# CY7112 EZ-PD™ PMG1-S2 MCU prototyping kit release notes

This is the second revision (Rev \*A) of the CY7112 EZ-PD™ PMG1-S2 MCU prototyping kit. This revision of the kit uses Rev04 of the CY7112 board. The board part number (600-60600-01) and revision (REV04) are marked on the top silkscreen of the board.

**Figure 1** Identifying CY7112 board revision

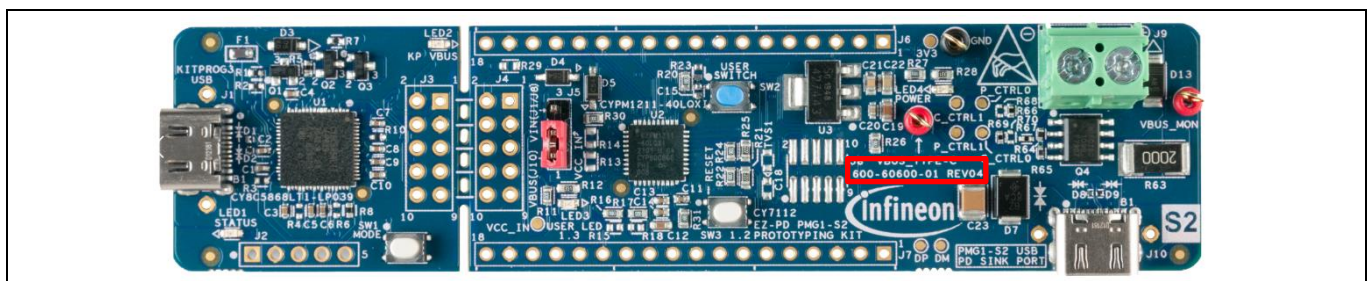
Following are the changes in the Rev04 of the kit hardware:

- The UART signals (Tx and Rx) between EZ-PD™ PMG1-S2 MCU and KitProg3 are connected by default. This eliminates the need to connect the UART signals using jumper wires as done in the earlier revision of the kit hardware.
- The color of the user switch (SW2) is changed to blue to differentiate from the reset switch (SW3) with the white color.
- A ground (GND) test point is added.
